FISH AND WILDLIFE SERVICE

April 20, 2018

In Reply Refer To: Great River Hydro, LLC
Vernon Hydroelectric Project, FERC No. 1904
Connecticut River
COMMENTS ON UPDATED STUDY REPORTS

Figure 1. Hypothetical example of graphically portraying forebay residency of each individually tagged fish in the supplemental study.

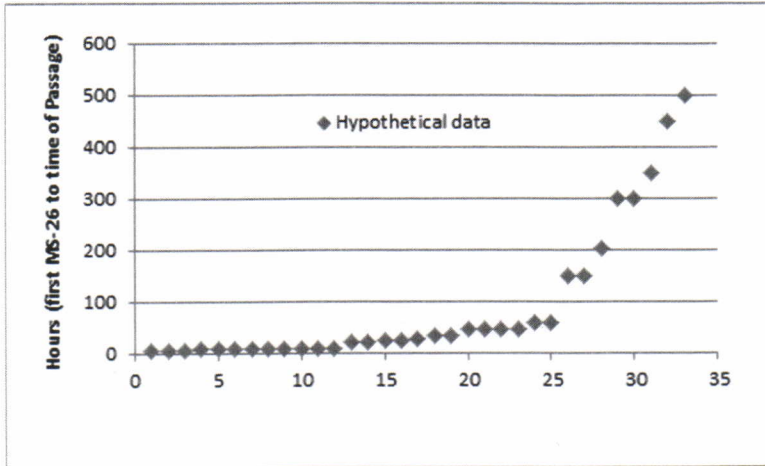
Also, we recommend supplementing the results of the forebay residency analysis with a data plot of tagged fish by the total period of time from first detection at MS-26 until passage (by any route) on the y-axis (see Figure 1, below). This figure will help better illustrate the range of observations.
